UI Bulletin #183

Subject: First responder installed equipment disables or shuts down when the LH doors of the vehicle are opened, or the Star/Stop button is pressed.

Models Chevrolet Tahoe

Affected: PPV (9C1) and SSV (5W4) models

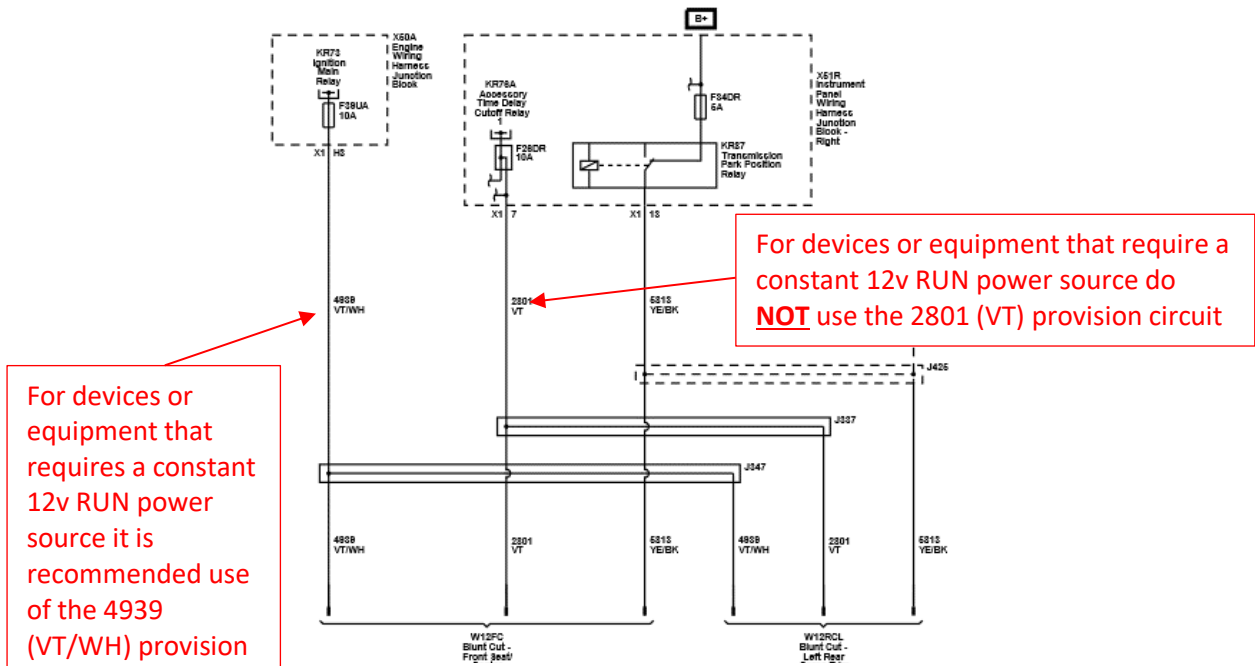
Some upfitter/customers may indicate that certain equipment installed will be disabled or shut-down when either of the vehicle's Driver or Passenger LH doors are opened or the Start/Stop button is pressed. This condition is caused when the installer/upfitter utilizes the Violet (VT) 2801 wire/circuit. This circuit is functionally tied to a feature called IRAP (Interruptible Retained Accessory Power). IRAP operates as described below and its function as noted is tied to the 2801 circuit and as such the devices connected to this power source are subjected to the power interruptions as well.

- The driver's side front door is opened.
- The driver's side rear door is opened.
- The S38 Vehicle On/Off Switch is pressed.

To avoid the power interruptions and provide a steady “RUN” mode power source for devices requiring such, it is recommended that the provisional 4939 (VT/WH wire) be used in place of the 2801 circuit. Refer to the schematic and notes below for more details.

For devices or equipment that requires a constant 12v RUN power source it is recommended use of the 4939 (VT/WH) provision circuit

For devices or equipment that require a constant 12v RUN power source do **NOT** use the 2801 (VT) provision circuit

Both the 2801 and 4939 provisional circuit are available in the blunt cut harnesses located in both the cargo and center console area
